ANP-10264NP-A
Revision 0

**U.S. EPR Piping Analysis and Pipe Support Design
Topical Report**

SUBJECT: FINAL SAFETY EVALUATION REPORT REGARDING ANP-10264NP, "U.S. EPR PIPING ANALYSIS AND PIPE SUPPORT DESIGN TOPICAL REPORT" (TAC NO. MD3128)

Figure 5-1: Model Isolation Methods of Division- Comparison of Qualification Boundaries

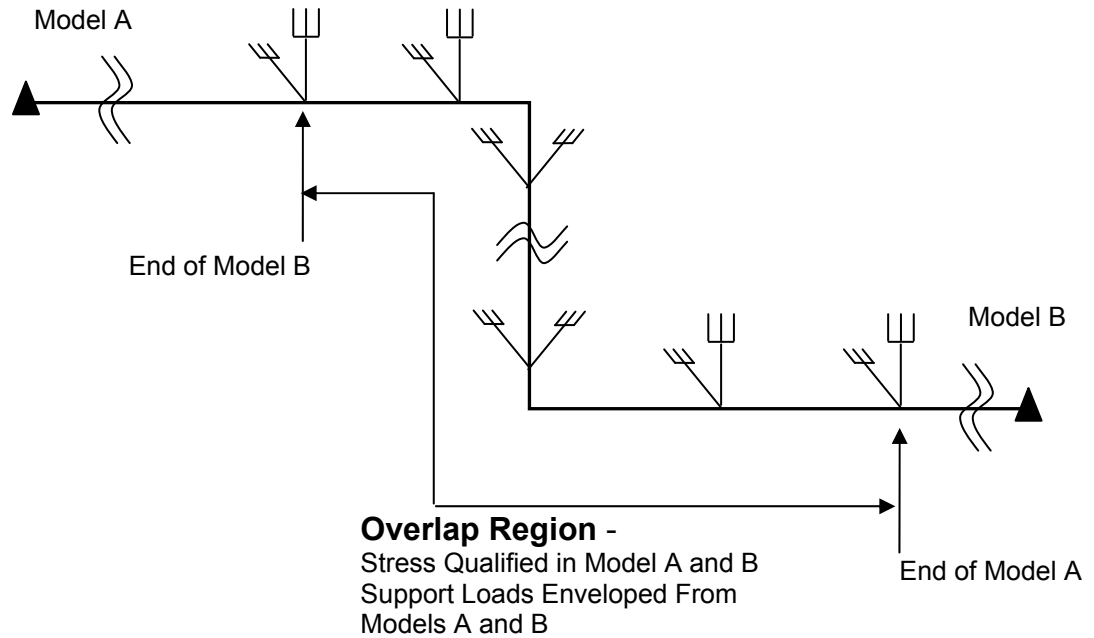
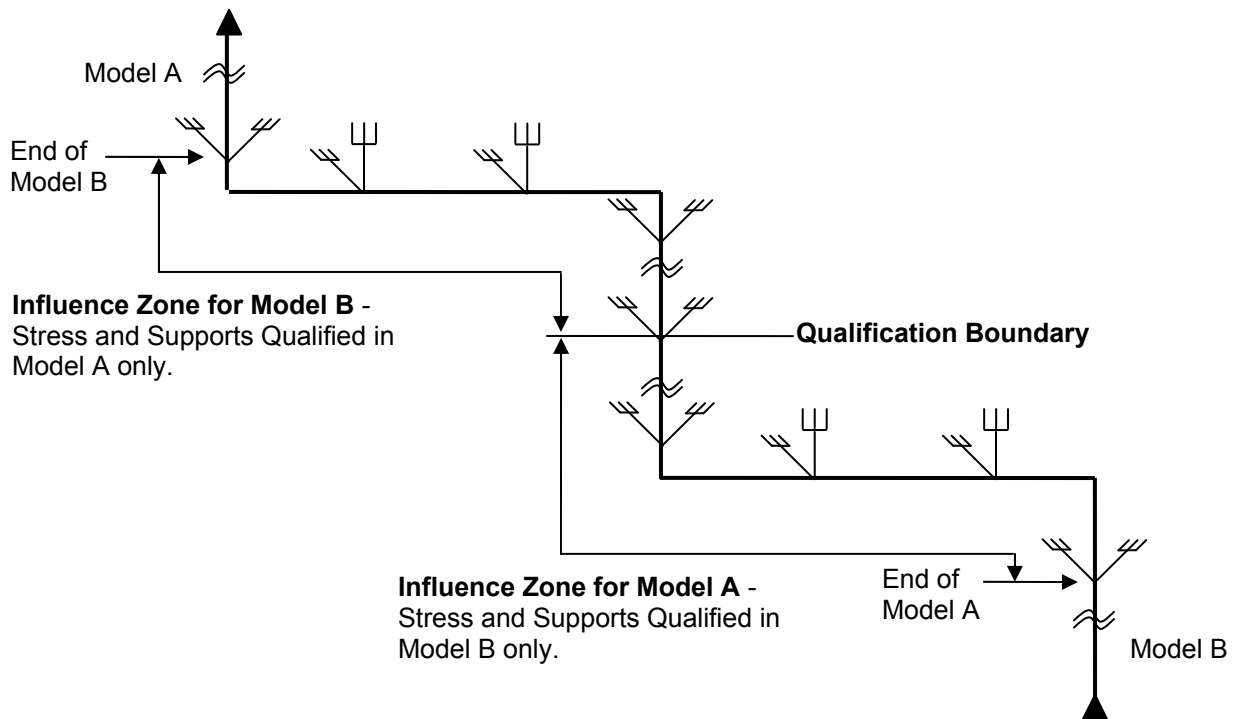
methods. Provide technical justifications and limitations (if any) for these two methods of isolating piping models. Also, discuss the basis for selecting the overlap region and the influence zone in TR Figure 5-3.

TR Sections 5.4.3.1 and 5.4.3.2 describe two approaches of dividing a large piping analysis model using the overlap region or the influence zone method. While these approaches may be technically sound, no references or technical justifications are provided for each of these methods. Provide technical justifications and limitations (if any) for these two methods of isolating piping models. Also, discuss the basis for selecting the overlap region and the influence zone in TR Figure 5-3.

As stated in TR Section 5.4.3, TR Figure 5-3 is included to show the differences in the boundaries of qualification for piping and supports when using the Overlap Method versus the Influence Zone Method. It is not used as a guide for selecting the overlap or influence zone regions. The title of the figure will be revised to “*Model Isolation Methods of Division - Comparison of Qualification Boundaries.*”

Section	Page	Change Description	Reference
Figure 5-1	5-12	Deleted old figures 5-1 and 5-2; Figure 5-3 renumbered as Figure 5-1 and revised in response to RAI 18 and RAI 19	AREVA NP letter NRC:07:028, dated 07/13/07, ANP-10264Q1 AREVA NP letter NRC:08:024, dated 4/18/08, ANP-10264Q1b
